Access Compliance Report

Public Rights-of-Way

(Curb Ramps)

Intersection ID: 42828	Main Street: ANN_BAKER_CT	Cross Street: LAMPLIGHTER_PL	Location: SE
ADA ID: AF5445D6F2EC	Ramp Type: BlendTrans2	Initial Pass/Fail: Fail	Overall Compliance: No
Severity Score: 36.25			
Codes/Mitigation Info/Possible Solution		Field Measurements/Component Compliance

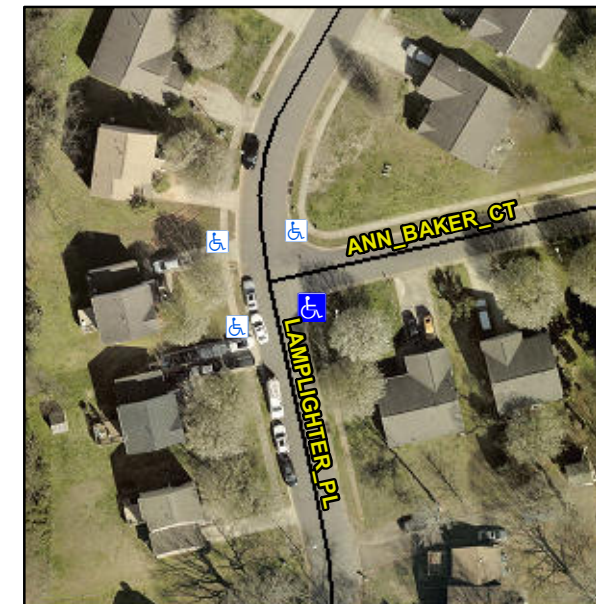
Not Found, R304.5.1, R304.5.3

Compliance	Description	Data	Compliance	Description	Data
N/A	Ramp Length (in)	97.0	Yes	BlendTrans Slope (%)	4.0
No	Ramp Width (in)	27.0	No	BlendTrans XSlope (%)	4.2
N/A	Flare Type LT	N/A	N/A	Flare Type RT	N/A
N/A	Flare Slope LT (%)	N/A	N/A	Flare Slope RT (%)	N/A
N/A	Flare Traversable LT?	N/A	N/A	Flare Traversable RT?	N/A
N/A	Landing Length (in)	N/A	N/A	DWS Provided?	N/A
N/A	Landing Width (in)	N/A	N/A	DWS Contrast?	N/A
N/A	Landing Slope (%)	N/A	N/A	DWS Length (in)	N/A
N/A	Landing X Slope (%)	N/A	N/A	DWS Full Width?	N/A
N/A	Landing Curb? (Y/N)	N/A	N/A	DWS Offset (in)	N/A
N/A	Shared Landing?	N/A			
N/A	Gutter Ponding?	N/A	N/A	Gutter Slope (%)	N/A
N/A	Gutter Lip Ht (in)	N/A	N/A	Gutter X Slope (%)	N/A
N/A	Painted X Walk1?	No	N/A	Painted X Walk2?	No
	X Walk 1 Direction	To N		X Walk 2 Direction	To W
	X Walk 1 Width (in)	N/A		X Walk 2 Width (in)	N/A
	X Walk 1 Slope (%)	2.0		X Walk 2 Slope (%)	0.6
	X Walk 1 X Slope (%)	1.0		X Walk 2 X Slope (%)	1.5

N/A	Ramp inside XWalk1?	N/A	N/A	Ramp inside XWalk2?	N/A
	Road Slope (%)	0.1		Clear Space?	N/A
	Road X Slope (%)	3.6	N/A	Clear Space to XWalk (in)	N/A
N/A	Any Obstructions?	N/A	N/A	Storm Grate/Utility Hazard?	N/A
	Obstruction Type			Storm Grate/Utility Type	
		N/A			N/A
			Yes	Surface Condition? (G/P)	Good
			No	Curb Slope (%)	10.4

Remove & Replace Curb Ramp With Two New Directional Ramps or Equivalent.
